Communication Plan  
Waterford 3 Steam Generator Inspection  
Scheduled for Refueling Outage 17  
(April 6, 2011 through May 5, 2011)

The following discussion points have been prepared to facilitate the conference call. This conference call is scheduled to occur towards the end of the planned SG tube inspections, but before the unit completes the inspections and repairs.

A graph of the primary-to-secondary leakage for Cycle 17 is shown below:

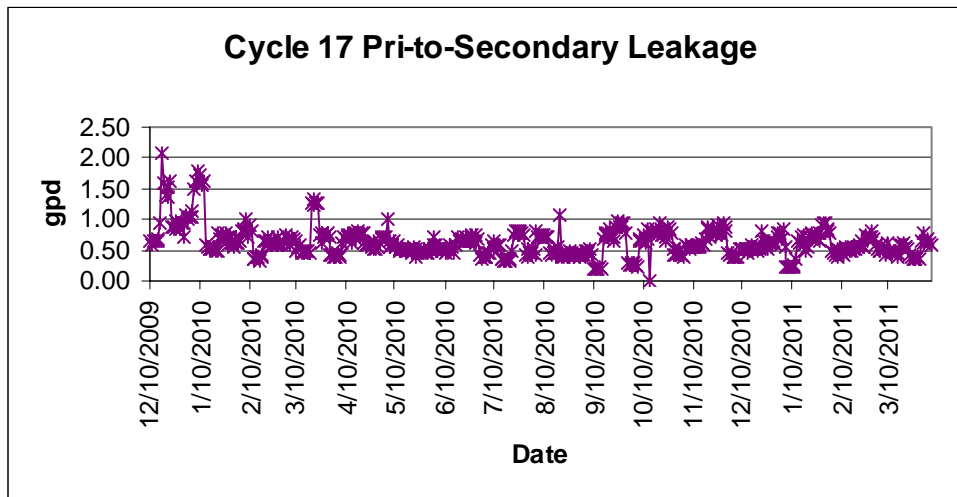
1. Discuss any trends in the amount of primary-to-secondary leakage observed during the recently completed cycle.

Primary to secondary Leakage has remained below 2 gpd for the entire cycle. Primary to secondary leakage has remained less than 1 gpd for the last 12 months.
